Question and Answer 1 regarding Lake George Library WAPs

Park County Public Libraries – Lake George

Wifi Access Points –Possible Locations/Installation Notes to aid in project

Lake George – 2 Access point recommended PoE

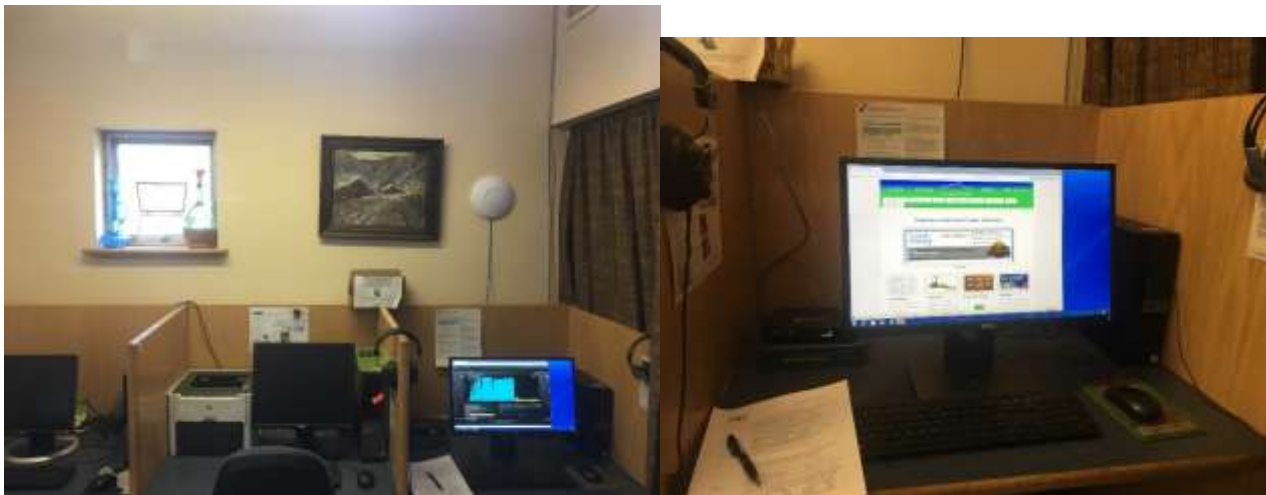
Question: On your RFPs and floor plans, I did not see markings to indicate potential locations for wireless access points. Can you identify locations for the wireless access points?

AP1 – Replace existing access point but use 20 foot cable to relocate around corner which should give the table area by windows better coverage. Or replace existing access point and use AP2 to accommodate meeting area and parking lot. No outlets or ethernet drops by those tables in meeting area.

AP2-Improved coverage for meeting area within building and parking lot area where patrons use WIFI extensively.
